SPARTAN CHASSIS, INC.

TSB07-170-002A

TECHNICAL SERVICE BULLETIN

SUBJECT: Engine - Rear Isolators

FIG. 3-1

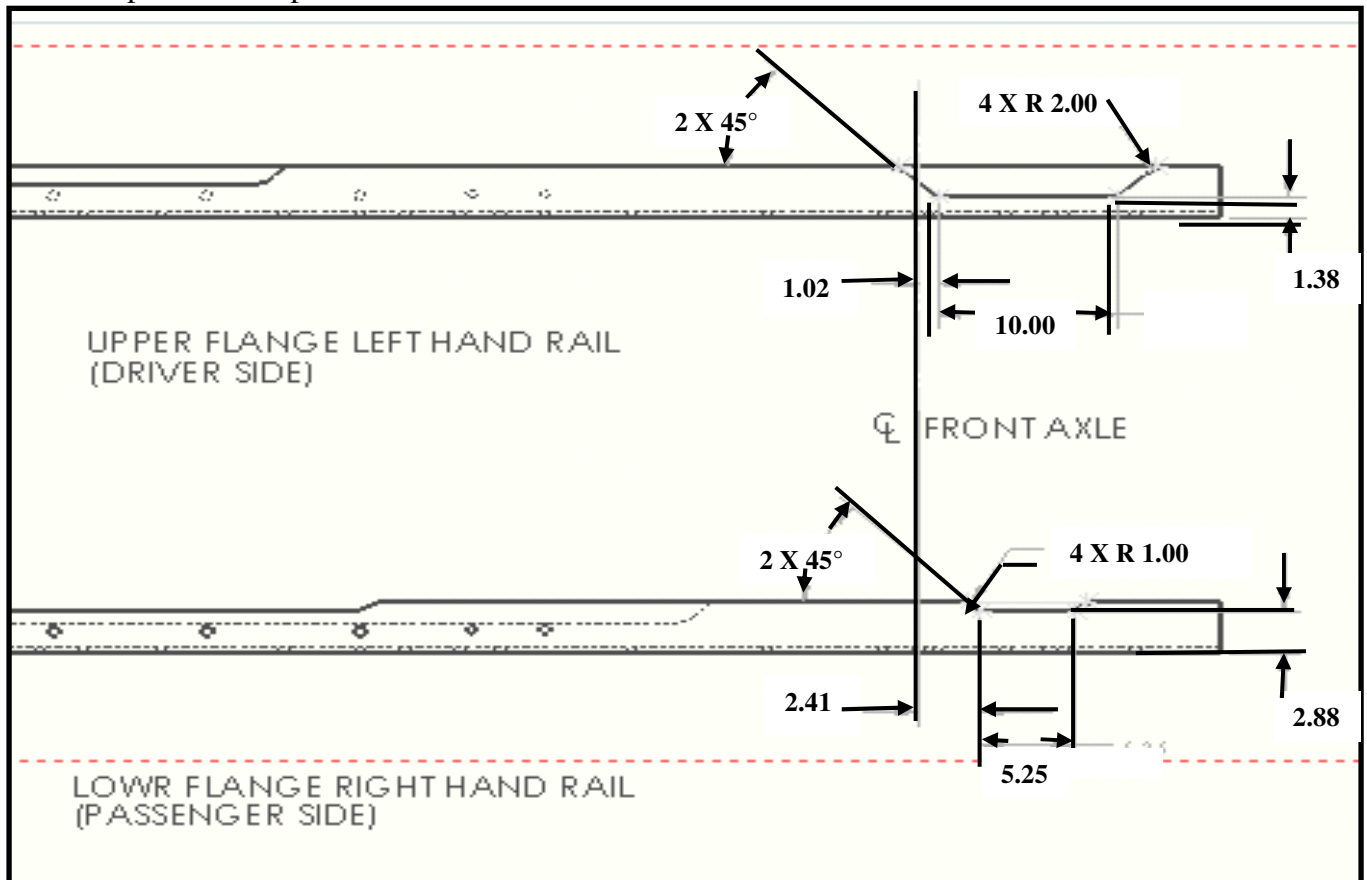
10. Refer to FIG. 3-1. Cut frame rail top left flange and right lower flange, left rail cutout has 1.00" inside radius, right rail cutout has 2.00" inside radius.

NOTE: Existing cut out on top left flange is to be increased. Thoroughly inspect all surrounding components for damage.

11. Grind cutouts smooth ensuring there are no notches. De-burr sharp corners and paint all bare surfaces.

FIG. 4-1

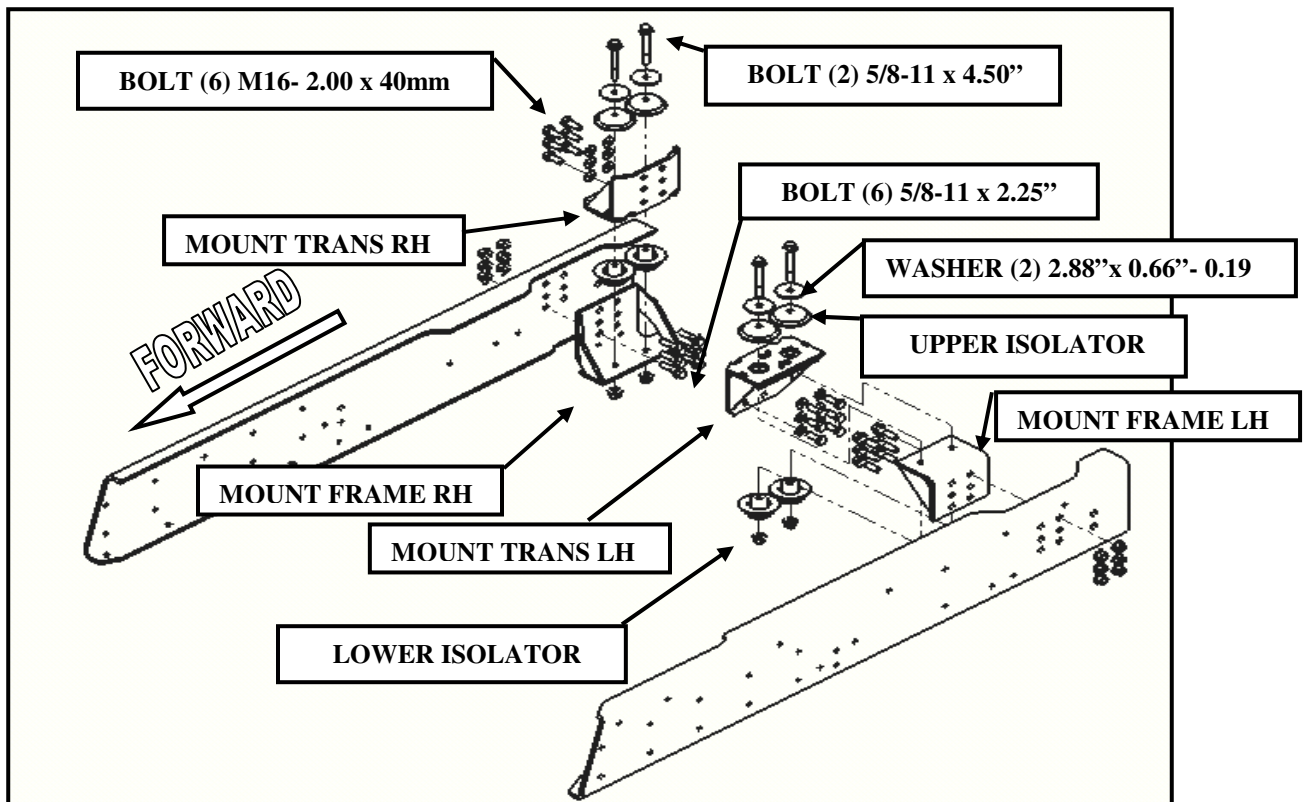
12. Refer to FIG. 4-1. Install new mount to passenger side frame rail using six (6) 5/8-11 X 2.25 flange head bolts supplied in the kit. Torque to 146 ft. lbs.
13. Refer to FIG. 4-1. Apply Loctite® 242® Threadlocker to the new M16-2.00 X 40 mm hex head bolts on the first five threads from the end. Install new mount to transmission using six (6) M16-2.00 X 40 mm hex head bolts and washers that you just applied threadlocker to. Torque to 182 ft. lbs.
14. Refer to FIG. 4-1. Place lower half of isolators on bottom of upper mounts. Secure isolator in place with tape.

15. Refer to FIG. 4-1. Place upper half of isolators on top of upper mounts place large washers on top of isolators. Insert two (2) 5/8-11 X 4.50 flange head bolts through washers and isolators.
16. Refer to FIG. 4-1. Lower and align isolators half until fully seated into mounts and install nuts. Torque to 238 ft. lbs.
17. Repeat steps 11 and 16 for opposite side.
18. Reinstall clamp holding wiring harnesses and hoses.
19. Reinstall exhaust tube and remove jack.
20. Reconnect batteries and lower cab.
